Safety Evaluation Report

With Open Items Related to the License Renewal of Prairie Island Nuclear Generating Plant Units 1 and 2

Docket Nos. 50-282 and 50-306

United States Nuclear Regulatory Commission

Figure 4.3-1

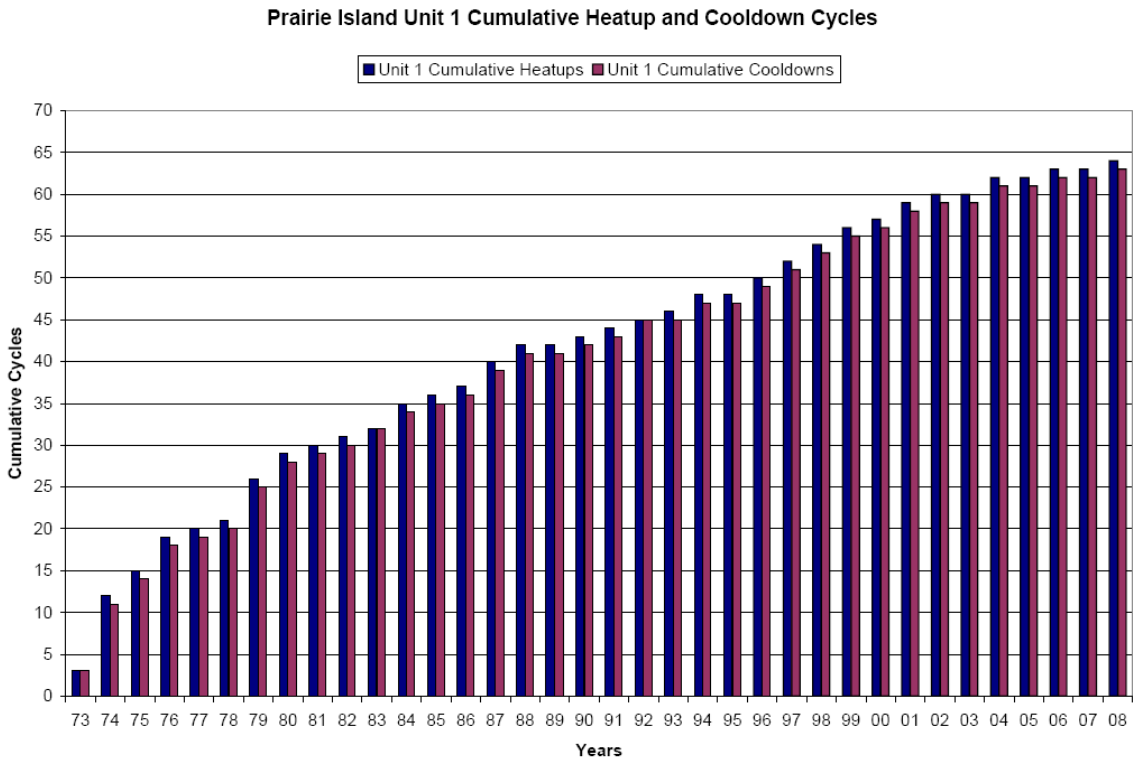
The staff reviewed these histograms and found that the transientoccurrence rates (both heatup and cooldown) are quite constant for Unit 1 since 1980 and for Unit 2 since 1983. This means that for the past 25 years, the PINGP (Units 1 and 2) plant operation has been quite steady. The applicant made its cycle projections based on the slope of a straight line connecting the time of the plant startup (1973 for Unit 1 and 1974 for Unit 2) and the last data point, 2008. It is clear from Figures 4.3-1 and 4.3-2, that the slope used by the applicant for making cycle projections is significantly greater than that of the average of the past 25 years. As expected, the slopes of event occurrence (i.e., the rates) during the first few years (5 to 7 years) are higher than the averages for both heatups and cooldowns. This means that the basis of projections that the applicant used is conservative and therefore, the staff found it to be acceptable.

Based on its review, the staff's concern on the transient event monitoring is resolved because the applicant provided the information requested and the information validates the PINGP fatigue management program and the applicant's assumption for the number and severity of transients.
